HINCKLEY NATIONAL RAIL FREIGHT INTERCHANGE

Applicant's Response to Deadline 4 Submissions [part 11 – Response to Mr Moore and Dr Moore]

Document reference: 18.17

9 February 2024

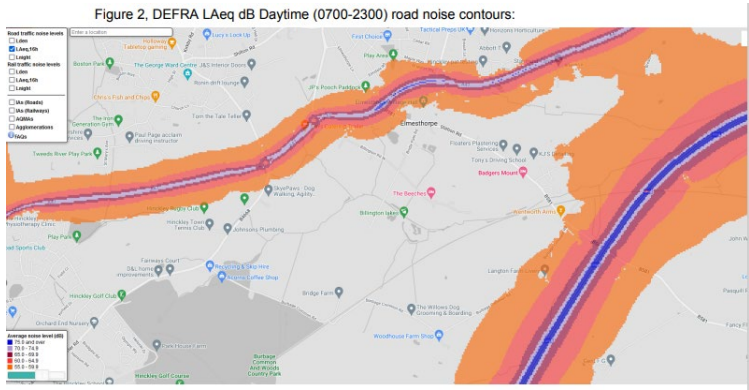
The applicant has submitted a document titled Written Statement of Oral Case ISH3 [Appendix F - Noise Assessment Update Note]. In a roundabout way, the applicant's document attempts to justify the absence of attenuation corrections to the sound of train pass bys measured by NMP4. Rail noise dominates NMP4's ambient sound levels The ambient sound levels measured by NMP4 are utterly dominated by sound of extremely close proximity train pass bys with far lower sound levels when trains aren't passing by, i.e. almost all the time. Overwhelming evidence of this is contained within the summary results pages for NMP4, as explained below in points 1-4. An example summary results page is included in Figure 1, below.

A response to this question was provided at Deadline 3 and is detailed within Written Statement of Oral Case ISH3 [Appendix F - Noise Assessment Update Note] (document 18.7.6, REP3-061). The response is summarised below.

The latest available DEFRA noise mapping data for the rail line has been reviewed and aligns with the noise levels measured at NMP4.
